RE: COMMUNICATION

ZONING BY-LAW AMENDMENT FILE Z.13.027

CLARZAN DEVELOPMENTS INC.

WARD 2 - VICINITY OF CLARENCE STREET AND RUTHERFORD ROAD

Revised Attachment #3

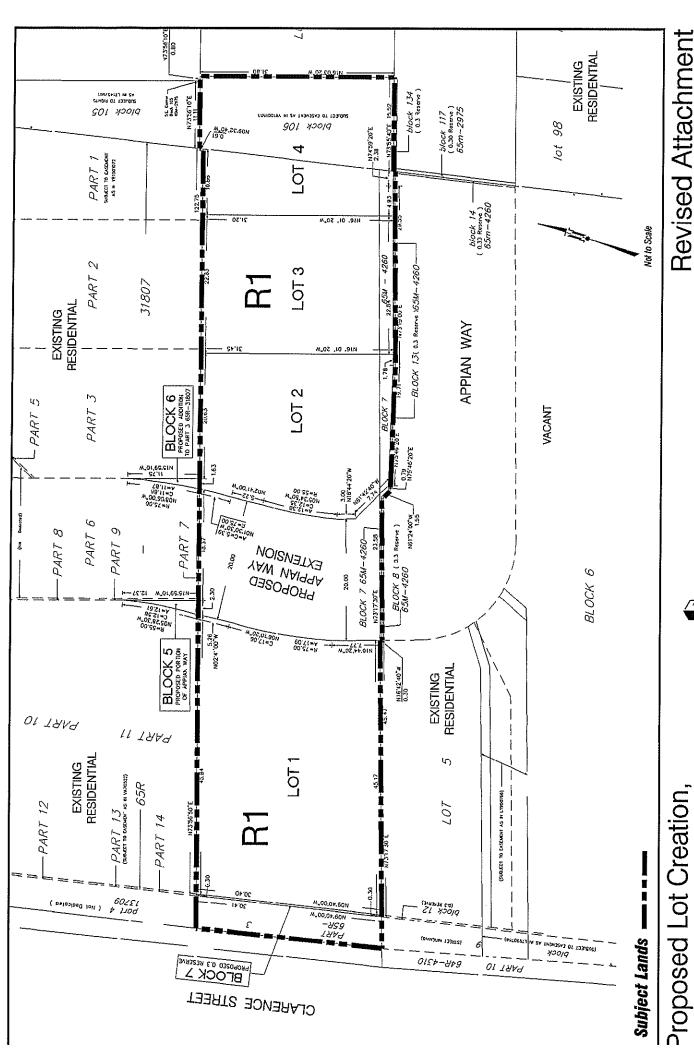
On February 13, 2015, Vaughan Planning staff received a revised lotting plan (see Revised Attachment #3 attached to this Communication) from the applicant, which showed a reduction in the number of lots abutting Clarence Street from 2 to 1 lot and a reduction in the overall number of lots in the plan from 5 to 4 lots all with minimum 18 m frontages in accordance with the R1 Residential Zone in Zoning By-law 1-88. The revised Lot 1 now has a lot frontage of 30.4 m. There is no change to the proposed 3 lots on the east side of the Appian Way road extension.

The applicant is also no longer pursuing a reduction in the front yard setback from 7.5 m to 4.5 m for Lots 2 to 4 on the revised lotting plan to this Communication, which staff did not support in its report. All homes sited on lots in the revised plan will have a minimum 7.5 m front yard setback. The applicant is proposing to comply with all zone requirements of the R1 Residential Zone (ie. no exceptions).

- "1. THAT Zoning By-law Amendment File Z.13.027 (Clarzan Developments Inc.) BE APPROVED, to amend Zoning By-law 1-88, specifically to rezone the subject lands from A Agricultural Zone and R1 Residential Zone, subject to site-specific Exception 9(845) and Exception 9(827) to R1 Residential Zone (minimum 18 m frontage with no exceptions to the R1 Zone standards), to facilitate the creation of 4 lots for detached dwelling units with frontage on Appian Way, in the manner shown on revised Attachment #3 to this Communication.

- 2. THAT the revised lotting pattern shown in "Revised Attachment #3" to this Communication, BE APPROVED, and replace Attachment #3 in the staff report."
